MOTHER BOARD MODIFICATION

FOR

TAPE CASSETTE ACCESSORY

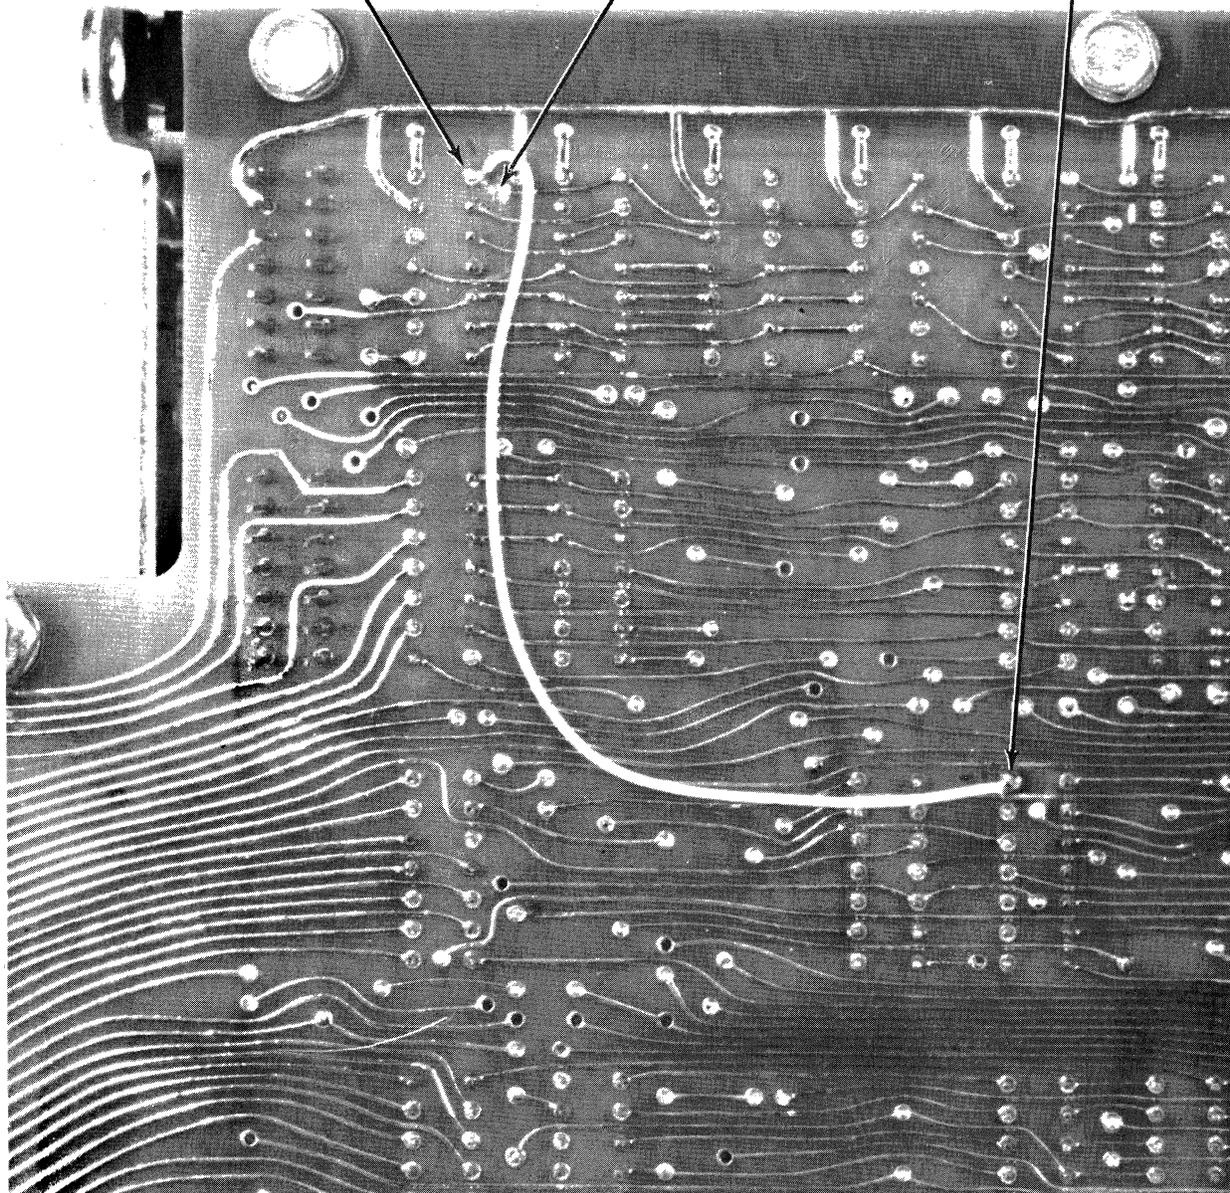
The following modification to the "A" or "B" Printer Mother Board enables the operation of the substitute function of the Tape Cassette Accessory. Also, as a result of this modification, the Printer can only be strapped to operate at 1200 baud rate with the SPEED switch set at the 15 or 30 position.

1. Remove bustle cover.
2. Remove Printer from top and bottom castings.
3. Remove top bustle screws and tilt bustle down.
4. Break run from R&P board connector A01 to PSC board connector A01 as shown by the illustration.

After breaking the run, thoroughly clean run fragments from the Mother Board.

5. Connect R&P board connector A01 to SPC board connector C14. Use 28 AWG or 30 AWG insulated wire.
6. Reinstall printer in castings, bustle and bustle cover.

BREAK RUN HERE
